Draft Informal document GRSP-62-15
(62nd GRSP, 11 - 15 December 2017,
agenda item 3(a))

Draft amendment 2 – Revision 1

Submitted by the Informal Working Group on global technical regulation No. 9

Figure 5, amend to read:

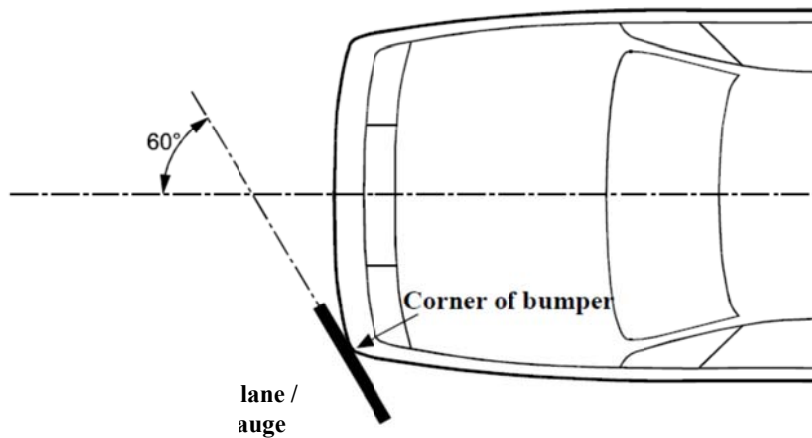
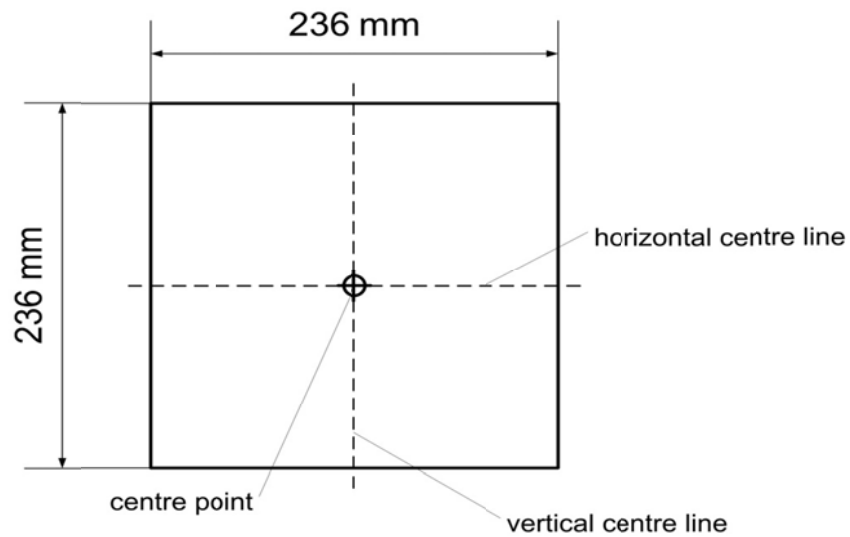
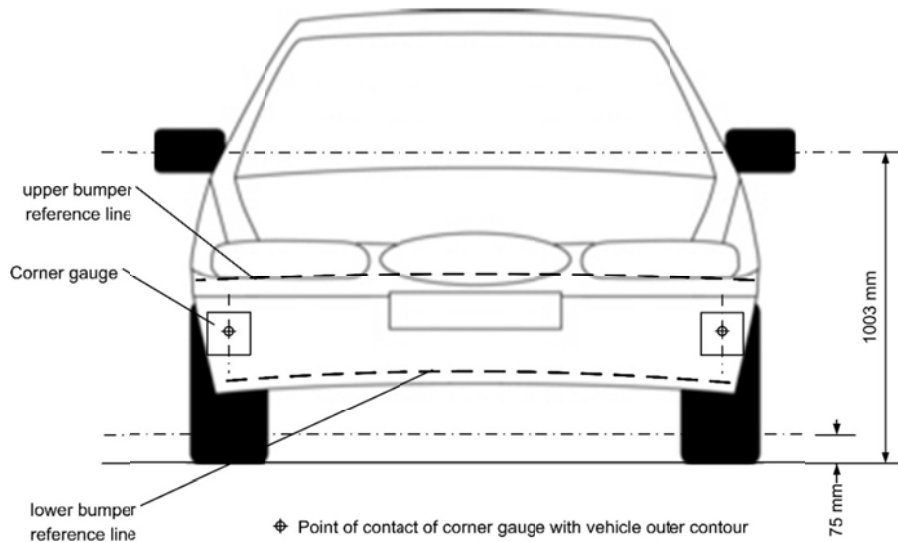
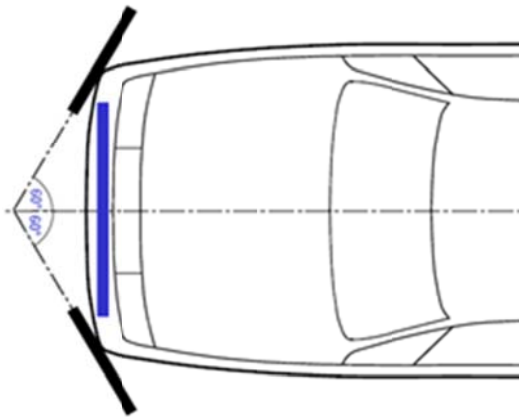
"3.14. **"Corner of bumper"** means ~~the transversal position of the vehicle's point of contact with a vertical plane which makes an angle of 60° with the vertical longitudinal plane of the vehicle and is tangential to the outer surface of the bumper (see Figure 5)~~ corner gauge as defined in Figure 5B.

For determination of the corner of bumper, the front surface of the corner gauge is moved parallel to a vertical plane with an angle of 60° to the vertical longitudinal centre plane of the vehicle (see Figures 5A and 5C) at any height of the centre point of the corner gauge between:

- (a) Equal to and above the point found on the vertical line intersecting the Lower Bumper Reference Line at the assessment position in transversal direction or at 75 mm above the ground reference plane, whichever is higher.
- (b) Equal to and below the point found on the vertical line intersecting the Upper Bumper Reference Line at the assessment position in transversal direction or at 1,003 mm above the ground reference plane, whichever is lower.

"Figure 12
Flexible lower legform impactor: Dimensions and centre of gravity locations of femur, knee joint and tibia (side view)

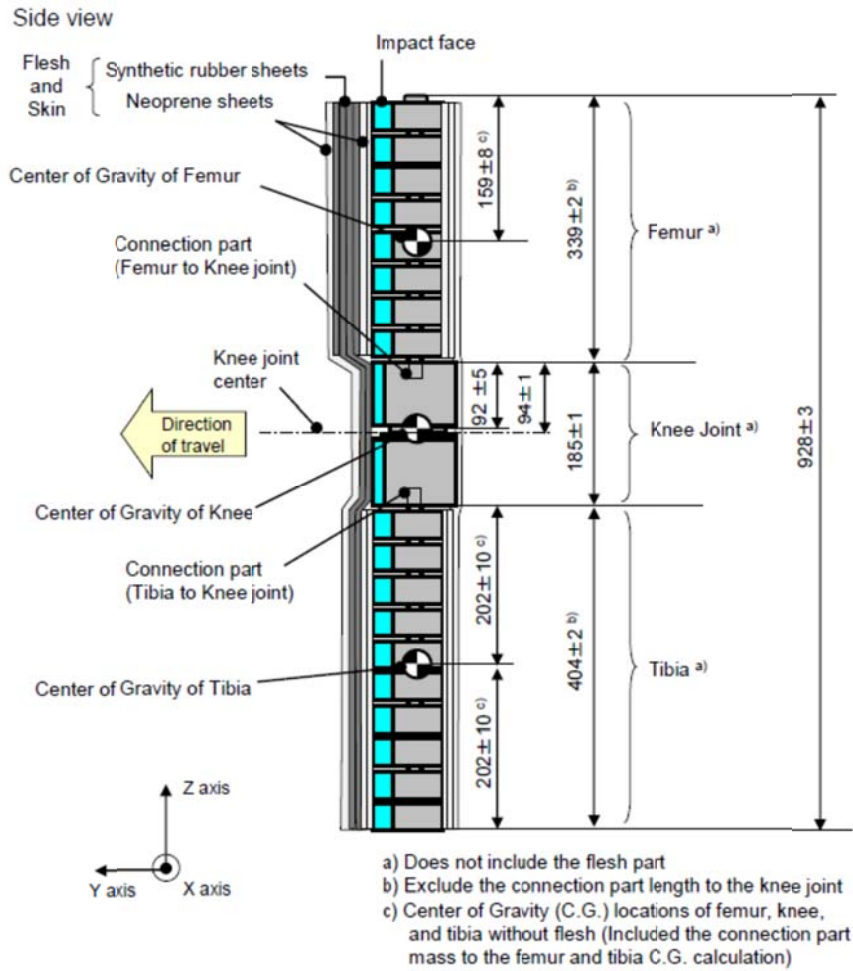
~~The assembled length of the impactor shall be 928 mm, having a total mass of 13.2 ± 0.4 kg. The dimensions of the fully assembled impactor shall be as defined in Figure 12, measured at the vertical centre line. When fully assembled in the impactor, the measurable lengths of the femur shall be 339 mm, of the knee joint shall be 185 mm and of the tibia shall be 404 mm. The knee joint centre position shall be 94 mm from the top of the knee joint at the vertical centre line of the knee.~~

The centres of gravity of the femur and tibia without the flesh and skin, including the connection parts to the knee joint, shall be as defined 159 ± 8 mm and 202 ± 10 mm respectively from the top, but not including the connection part to the knee joint, of each part as shown in Figure 12. The centre of gravity of the knee joint shall be as defined 92 ± 5 mm from the top of the knee joint as shown in Figure 12.

Figure 13
Flexible lower legform impactor: Schematic plan views of femur, tibia, and knee dimensions (top view, main body segments)

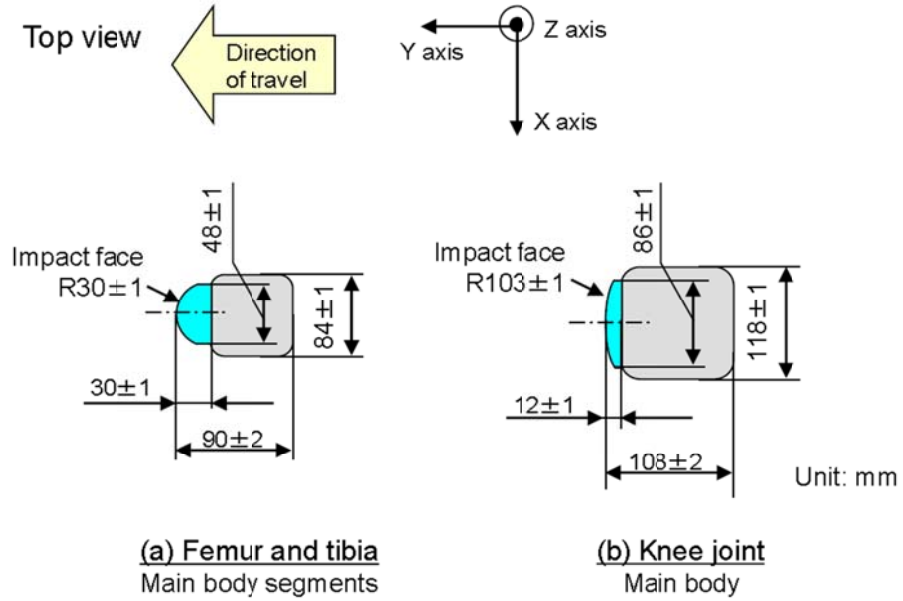
- "6.3.1.1.1. **The cross-sectional shape of the femur main body segments, the tibia main body segments and their impact faces shall be as defined perpendicular to the Z-axis of the femur and the tibia main body segments shall be 90 mm in width along the Y-axis, and 84 mm in width along the X-axis as shown in Figure 13 (a). The impact face shall be 30 mm in radius, 30 mm in width along the Y-axis, and 48 mm in width along the X-axis as shown in Figure 13 (a).**

- 6.3.1.1.2. **The cross-sectional shape of the knee joint and its impact face shall be as defined perpendicular to the Z-axis of the knee joint shall be 108 mm in width along the Y-axis, and 118 mm in width along the X-axis as shown in Figure 13 (b). The impact face shall be 103 mm in radius, 12 mm in width along the Y-axis, and 86 mm in width along the X-axis as shown in Figure 13 (b).**

Figure 14
Flexible lower legform impactor: Flesh and skin dimensions

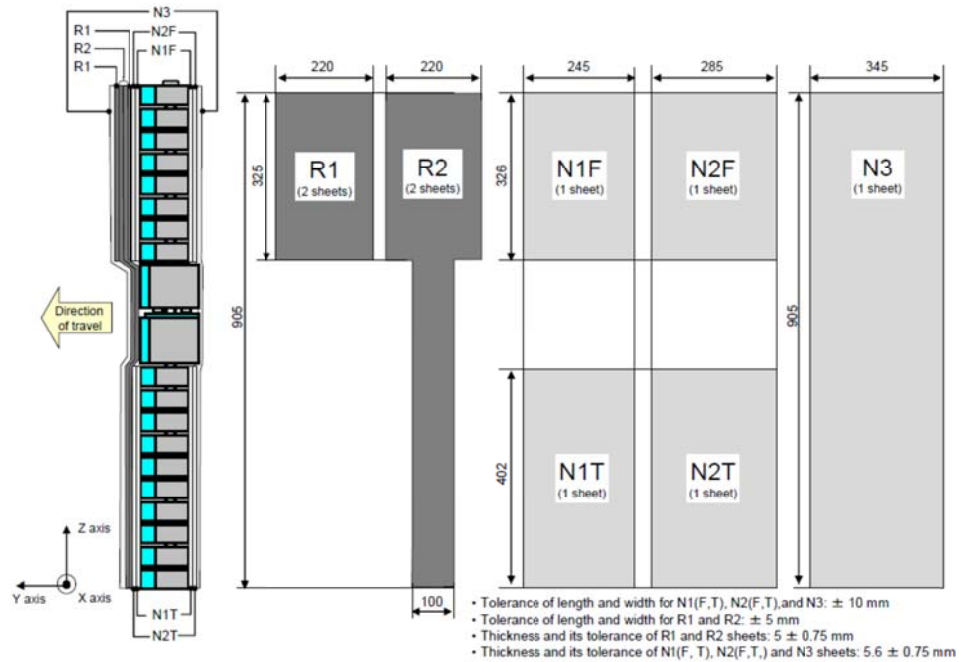
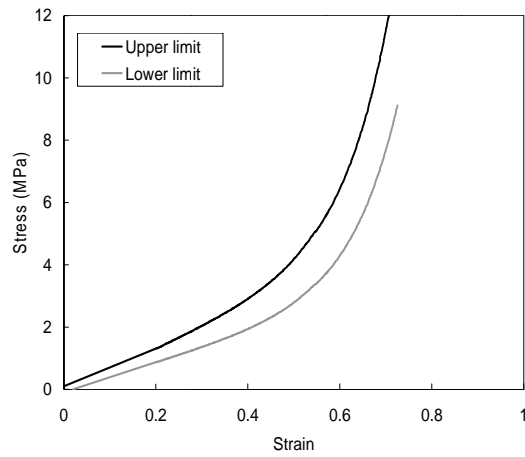
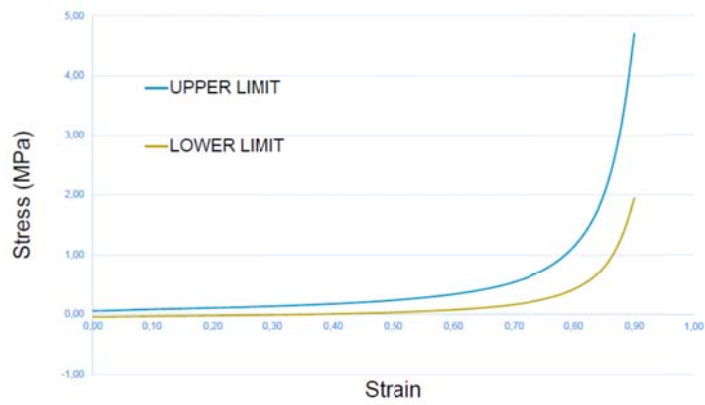
sheets (R1, R2) and foamed neoprene sheets (N1F, N2F, N1T, N2T, N3) as shown in Figure 14. The size of the sheets shall be within the requirements described in Figure 145. The sheets are required to have compression characteristics as shown in Figure 15. The compression characteristics shall be checked using material from the same batch as the sheets used for the impactor flesh and skin.

Figure 16
Flexible lower legform impactor: ~~Instrument~~ **Location of the transducers**

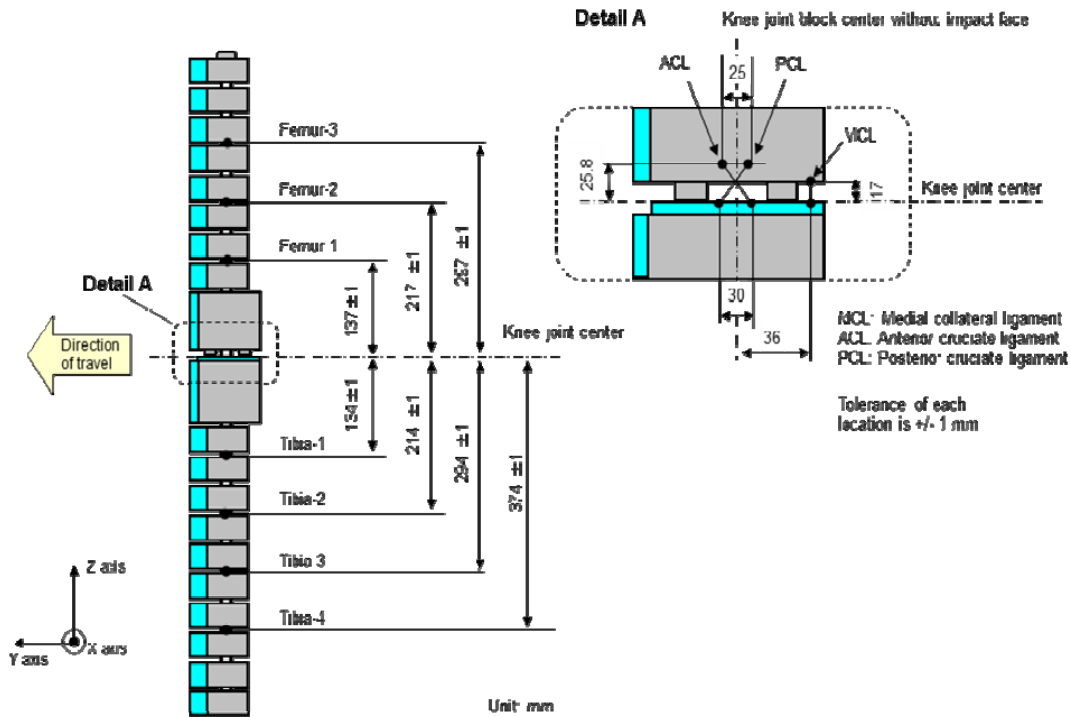
- 6.3.1.1.6.1. Four transducers shall be installed in the tibia to measure bending moments at locations within the tibia. ~~The sensing locations of each of the transducers are as follows: tibia 1: 134 mm, tibia 2: 214 mm, tibia 3: 294 mm and tibia 4: 374 mm below the knee joint centre respectively as shown in Figure 16.~~

~~Three transducers shall be installed in the femur to measure bending moments applied to the femur. The sensing locations of each of the transducers are as follows: femur 1: 137 mm, femur 2: 217 mm and femur 3: 297 mm above the knee joint centre, respectively, as shown The sensing locations of each of the transducers are as defined in Figure 16.~~

"Figure 20

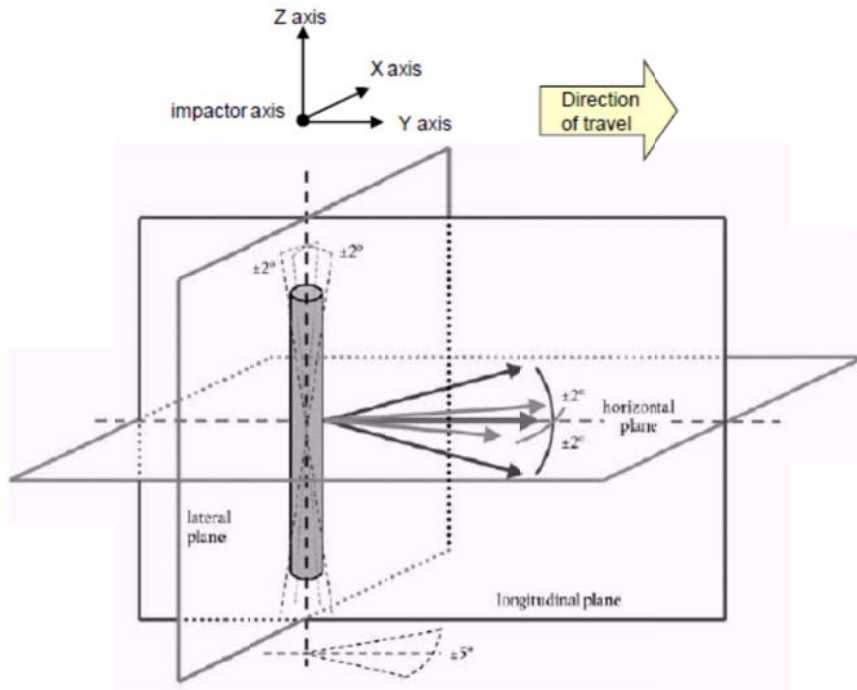
7.1.1.2. **The direction of the impact velocity vector shall be in the horizontal plane and parallel to the longitudinal vertical plane of the vehicle. The tolerance for the direction of the velocity vector in the horizontal plane and in the longitudinal plane shall be $\pm 2^\circ$ at the time of first contact. The axis of the impactor shall be perpendicular to the horizontal plane, with a roll and pitch angle tolerance of $\pm 2^\circ$ in the lateral and longitudinal plane. The horizontal, longitudinal and lateral planes are orthogonal to each other (see Figure 20).**

- 7.1.1.3.2. **At the time of first contact the impactor shall have the intended orientation about its vertical axis, for the correct operation of its knee joint, with a yaw angle tolerance of $\pm 5^\circ$ (see Figure 20).**

Figure 21

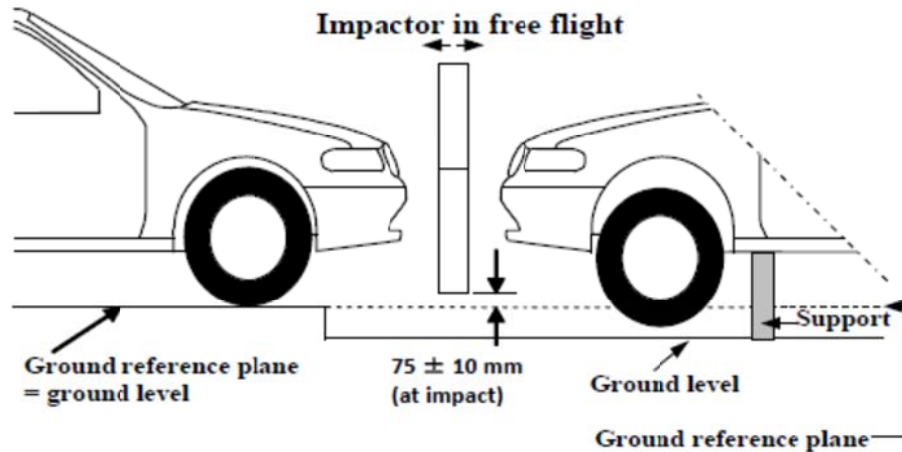
7.1.1.3. **The bottom of the impactor (without parts needed for the purposes of launching and/or protection) shall be 75 mm above the ground reference plane at the time of the first contact with the bumper (see Figure 21), with a tolerance of ± 10 mm. When setting the height of the propulsion system, an allowance ~~must~~**shall** be made for the influence of gravity during the period of free flight of the impactor.**

~~The bottom of the impactor shall be at 25 mm above ground reference plane at the time of first contact with the bumper (see Figure 17), with a ± 10 mm tolerance. When setting the height of the propulsion system, an allowance must be made for the influence of gravity during the period of free flight of the impactor.~~

Figure 22

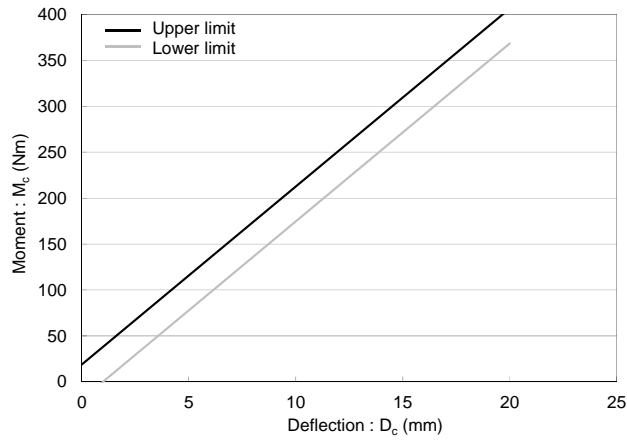
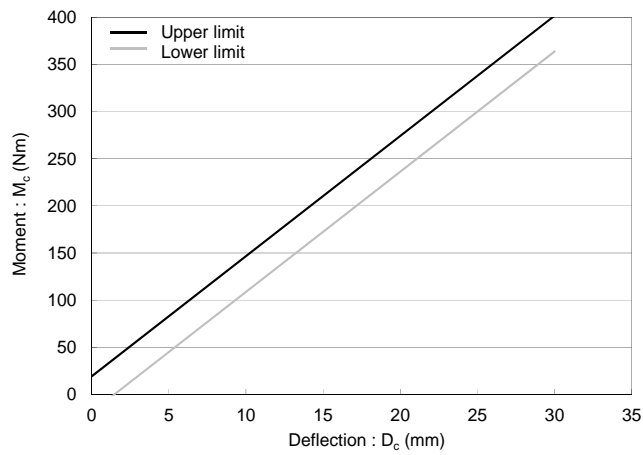
- 8.1.1.2. **When the femur and the tibia of the impactor, *without flesh and skin*, are loaded in bending in accordance with paragraph 8.1.1.4., the applied moment and the generated deflection at the centre of the femur and the tibia (M_c and D_c) shall be within the corridors shown in Figure 22.**

~~When the impactor is loaded in bending in accordance with paragraph 8.1.1.4., the applied force/bending angle response shall be within the limits shown in Figure 18. Also, the energy taken to generate 15.0° of bending shall be $100 \pm 7\text{ J}$.~~

Figure 23
Flexible lower legform impactor: Requirement corridors for the knee joint, without flesh and skin, in the static certification test (see paragraph 8.1.1.3.)

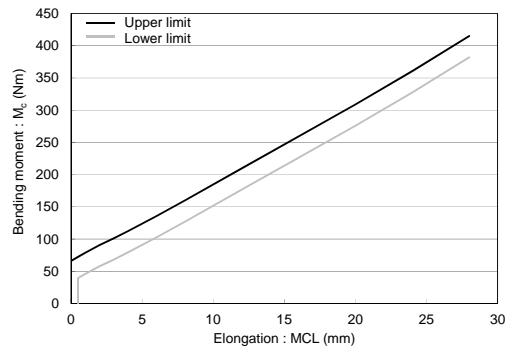
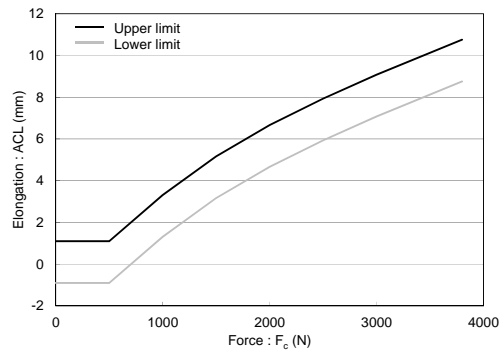
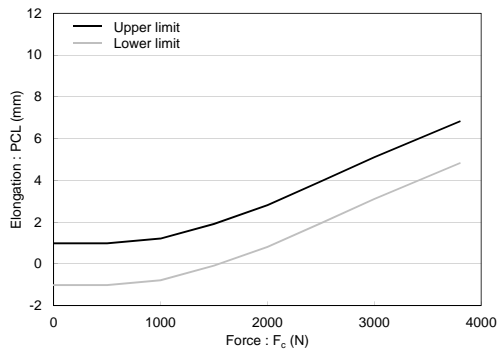
- 8.1.1.3. **When the knee joint of the impactor, *without flesh and skin*, is loaded in bending in accordance with paragraph 8.1.1.5., the MCL, ACL, and PCL elongations and applied bending moment or the force at the centre of the knee joint (M_c or F_c) shall be within the corridors shown in Figure 23.**

~~When the impactor is loaded in shearing in accordance with paragraph 8.1.1.5., the applied force/shearing displacement response shall be within the limits shown in Figure 19.~~

Figure 24
Flexible lower legform impactor: Impactor-t Test set-up for the femur in the static certification test (see paragraph 8.1.1.4.)

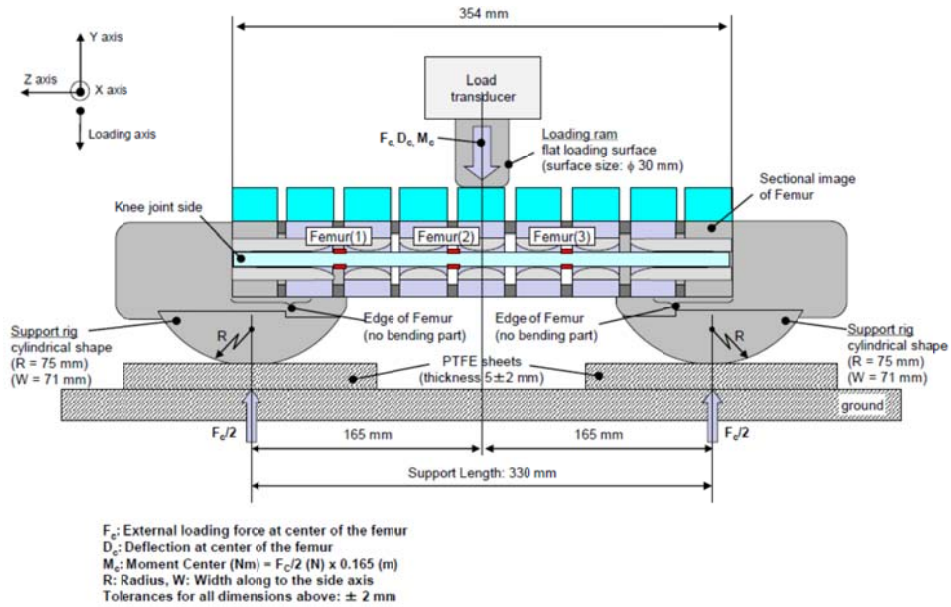
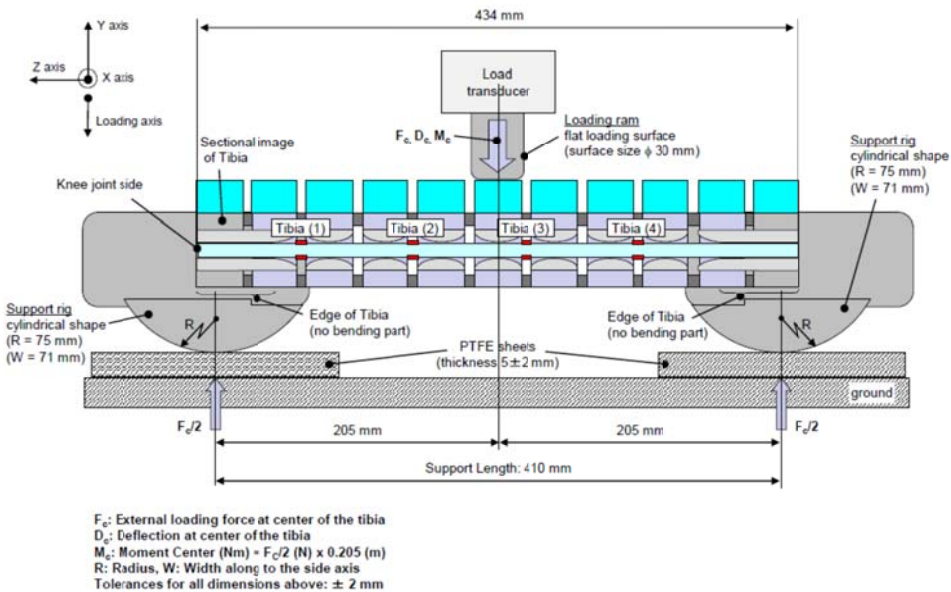
- 8.1.1.4. **The edges of the femur and tibia, *without flesh and skin*, not bending parts, shall be mounted to the support rig firmly as shown in Figure 24 and Figure 25. The Y-axis of the impactor shall be parallel to the loading axis within $180 \pm 2^\circ$ tolerance. To obtain repeatable loading, low friction Polytetrafluoroethylene (PTFE) plastic pads are used under each support (see Figures 24 and 25).**

~~The impactor, without foam covering and skin, shall be mounted with the tibia firmly clamped to a fixed horizontal surface and a metal tube connected firmly to the femur, as shown in Figure 20. The rotational axis of impactor knee joint shall be vertical. To avoid friction errors, no support shall be~~

Figure 26

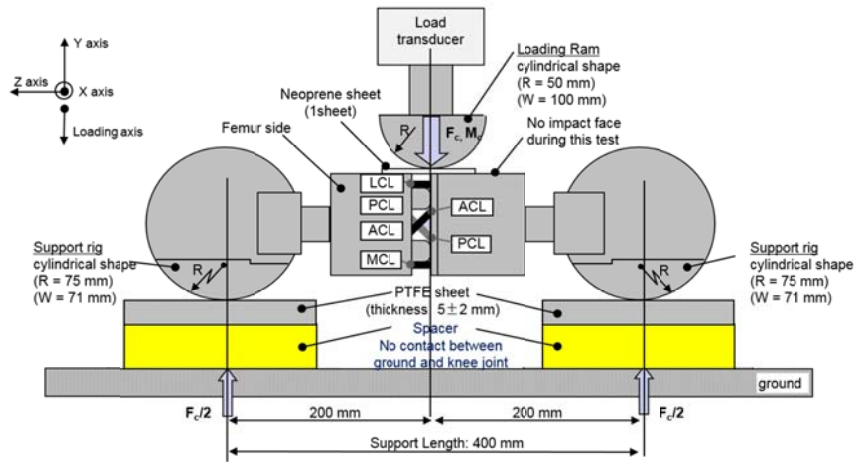
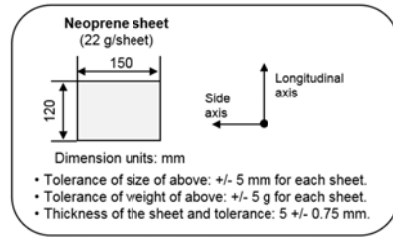
- 8.1.1.5. The ends of the knee joint, **without flesh and skin**, shall be mounted to the support rig firmly as shown in Figure 26. The Y-axis of the impactor shall be parallel to the loading axis within $\pm 2^\circ$ tolerance. To obtain repeatable loading, low friction Polytetrafluoroethylene (PTFE) plastic pads are used under each support (see ~~f~~Figure 26). To avoid impactor damage, a **foamed** neoprene sheet shall be set **underneath between** the loading ram and the impactor face of the knee joint which is described in ~~the~~Figure 1326 shall be removed. The **foamed** neoprene sheet used in this test shall have compression characteristics as shown in Figure 15.

The centre of the loading force shall be applied at the knee joint centre within $\pm 2^\circ$ mm tolerance along the Z-axis (see ~~f~~Figure 12). The external load shall be increased so as to maintain a deflection rate between 10 and 100 mm/minute until the bending moment at the centre part of the knee joint (M_c) reaches 400 Nm.

~~The impactor, without foam covering and skin, shall be mounted with the tibia firmly clamped to a fixed horizontal surface and a metal tube connected firmly to the femur and restrained at 2.0 m from the centre of the knee joint, as shown in Figure 21.~~
